# **STAFF REPORT**

# Minor Subdivision #25-004 6E Minor Subdivision Date: October28<sup>th</sup>, 2025

**REQUEST:** Requesting approval for a minor subdivision that will create a total of two (2) lots. Located at 560 6<sup>th</sup> Street, in Penrose.

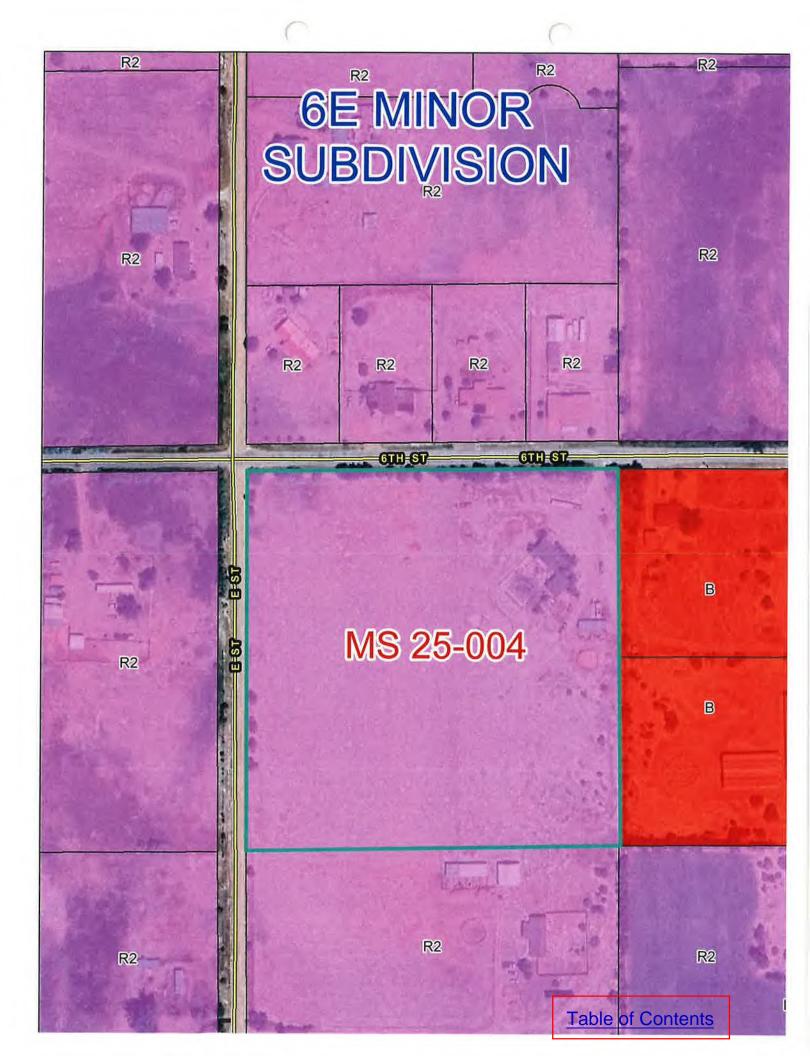
- 1. Remove the note from the plat "ALONG WITH A SPECIFIC SEPTIC DESIGN AND ADDRESS".
- 2. Plat note that states the N/W corner of lot 1 be the primary OWTS location.

- 1. Remove note from plat "Along with a specific septic design and address"
- 2. Plat note that states the NW corner of lot 1 be the primary OWTS location.

DRAINAGE PLAN FOR LOT 1 WAS DEFERRED TO THE TIME OF DEVELOPMENT.
THEREFOR PRIOR TO BUILDING, A SITE SPECIFIC DRAINAGE PLAN WILL BE REQUIRED.
ALONG WITH A SPECIFIC SEPTIC DESIGN AND ADDRESS.
